**CAMDEN FAMILY HEALTH, INC.
NICHOLAS COUNTY, WEST VIRGINIA
CAMDEN-ON-GAULEY RICHWOOD CLINIC**

ADDENDUM #3

June 30, 2022

THRASHER PROJECT #060-10260

DRAWN: SGF DATE: 6/1/2022
 CHECKED: CCA DATE: 6/1/2022
 APPROVED: CCA DATE: 6/1/2022
 PROJECT No. 060-10280
 SHEET No. **A4.01**
 INTERIOR ELEVATIONS

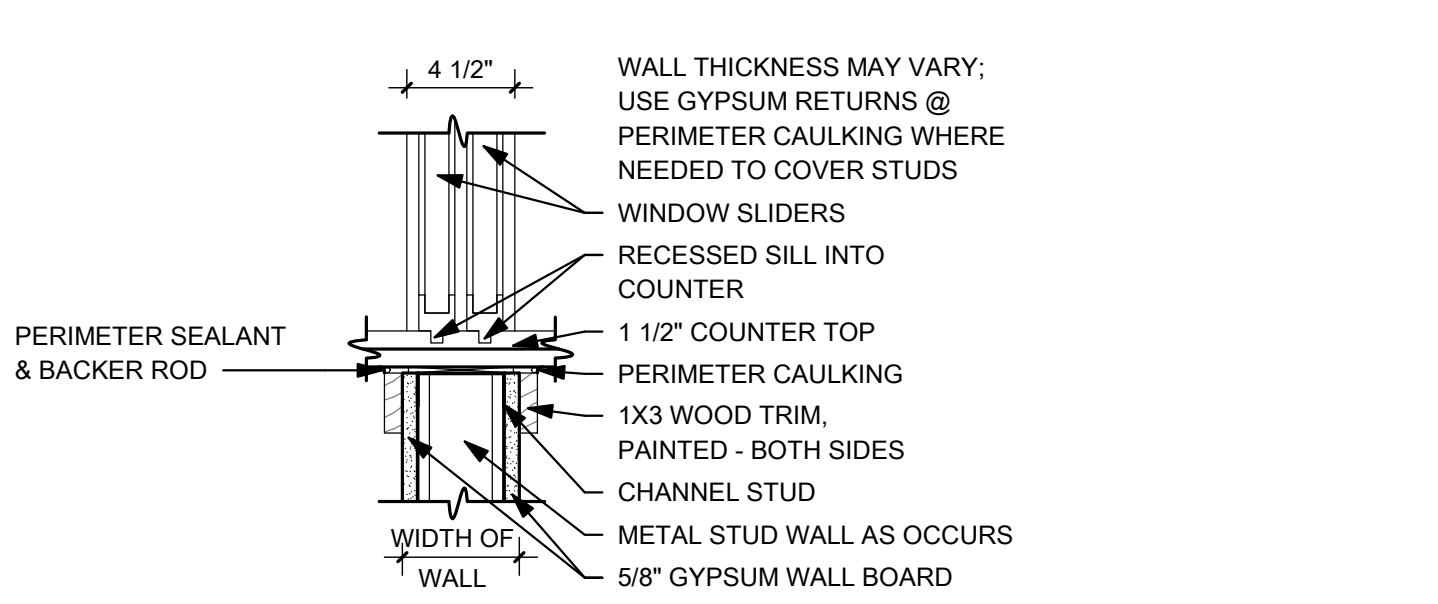
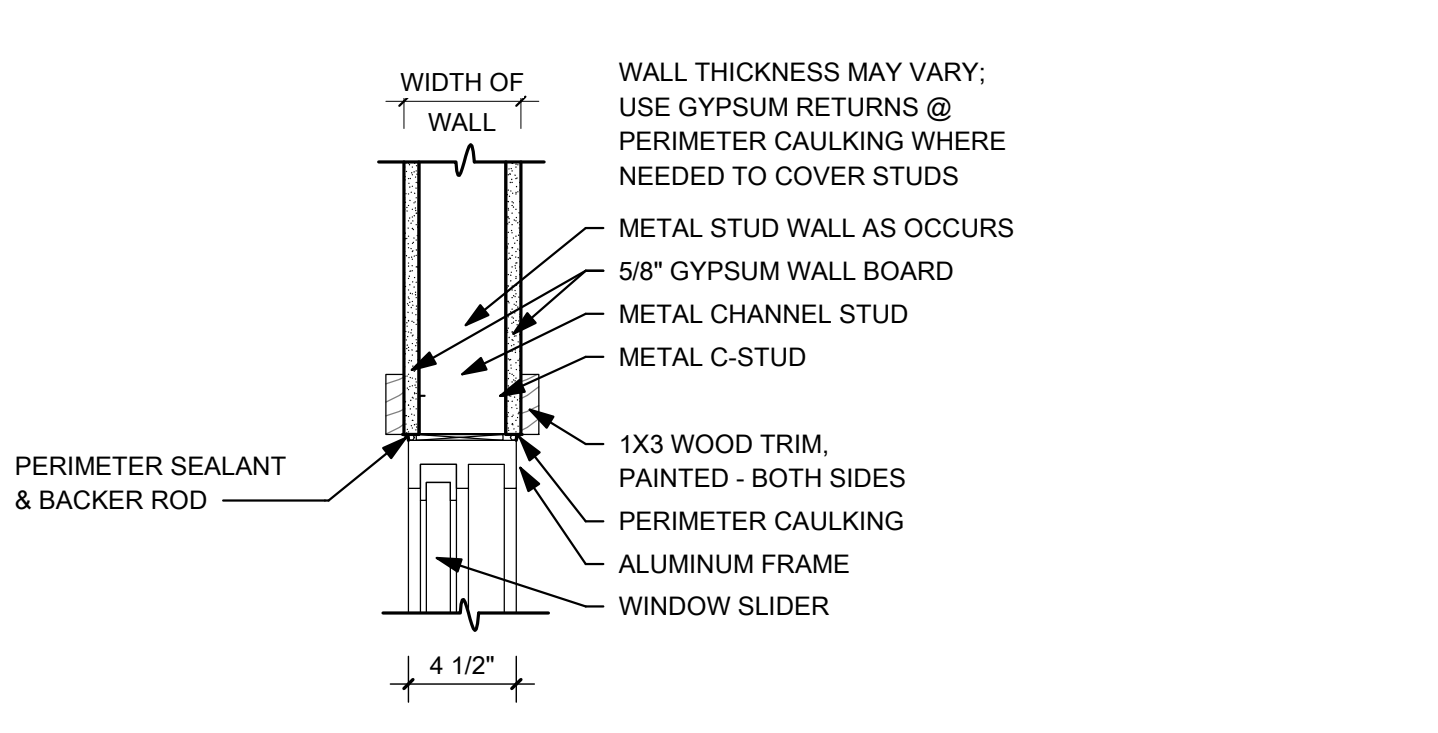
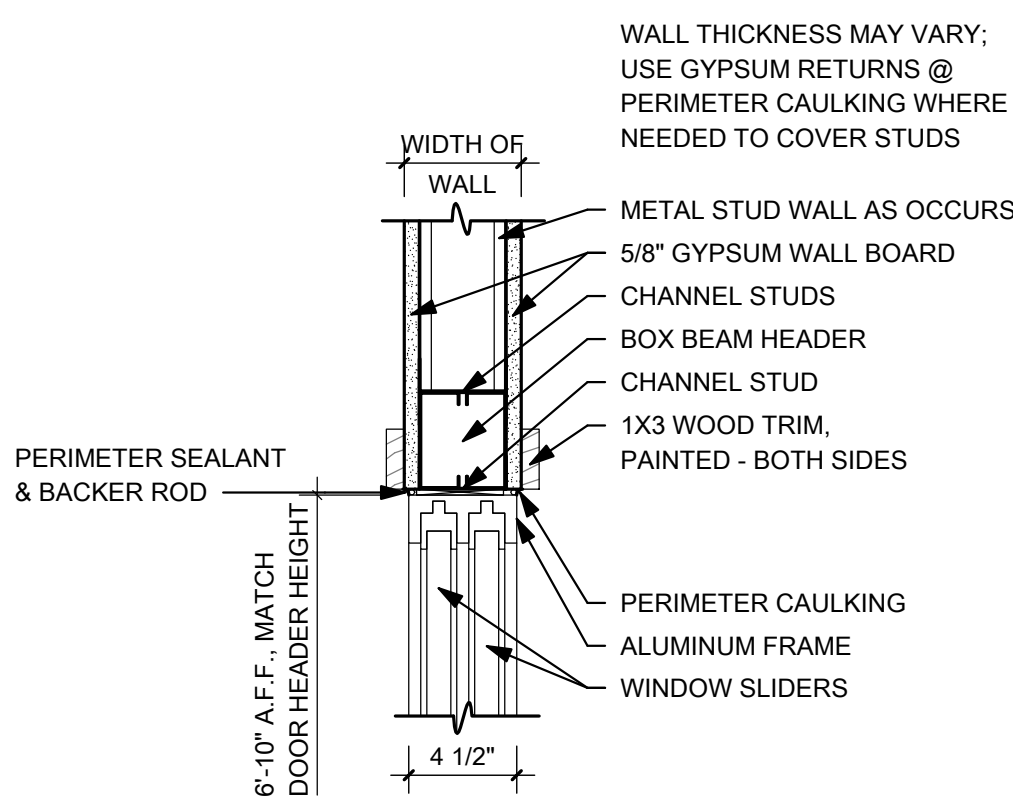
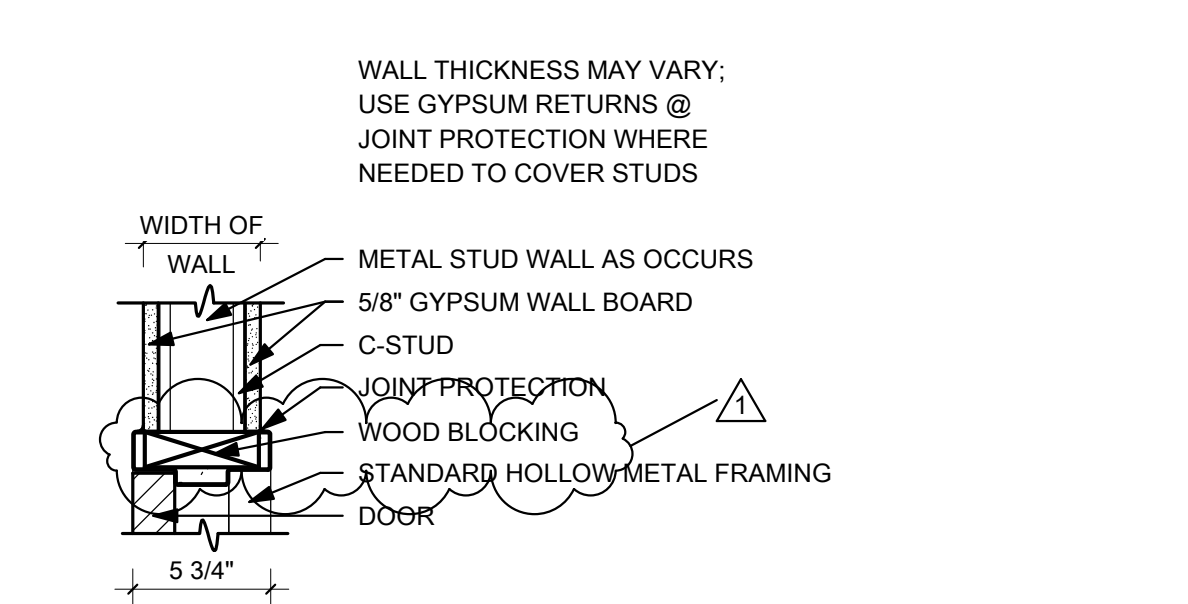
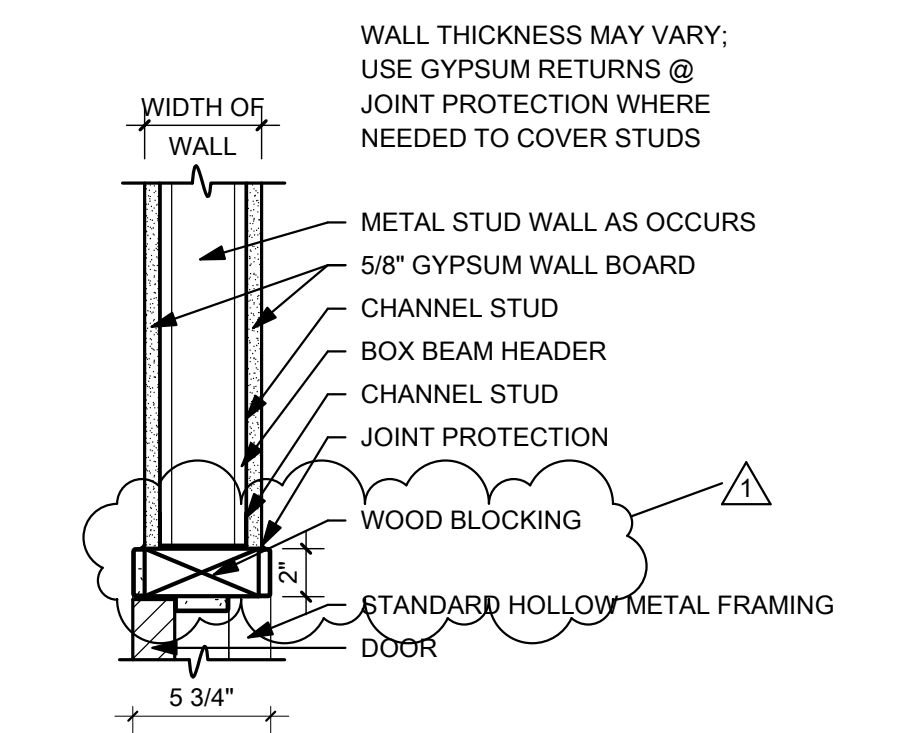
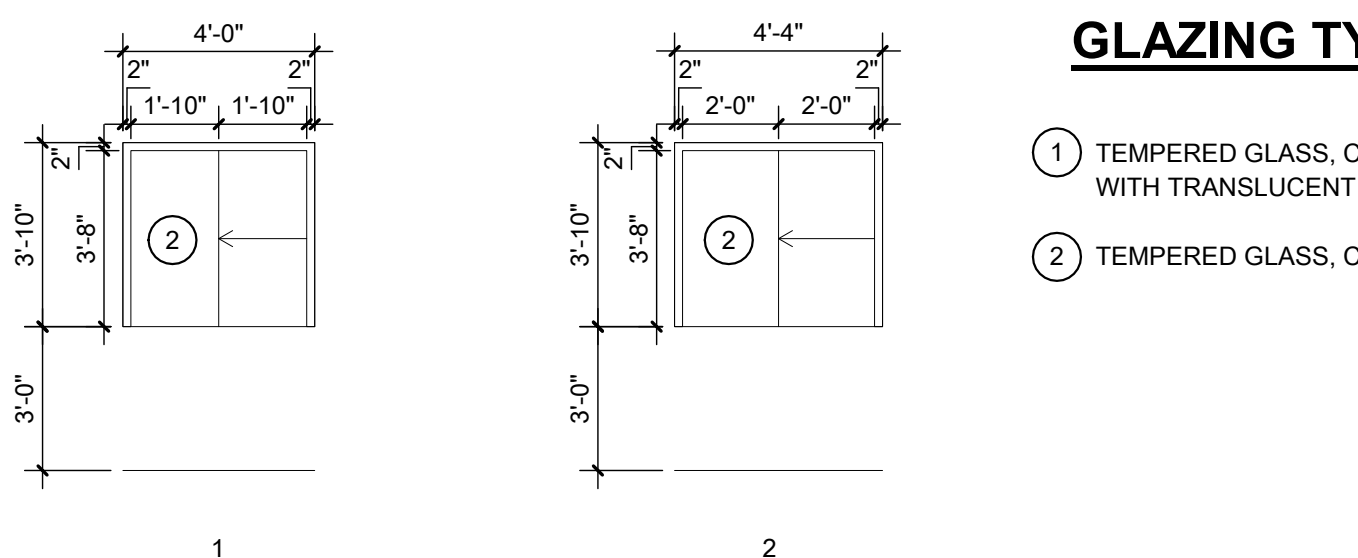
5. On Page #A4.01 “Interior Elevations (Restrooms)”, Keyed Note #s: 2, 3, 7, 8, 12, 13 & 14 are not tagged. Please clarify if these items are in scope.

OMIT THESE ITEMS FROM PROJECT

These items are not included and shall be omitted.
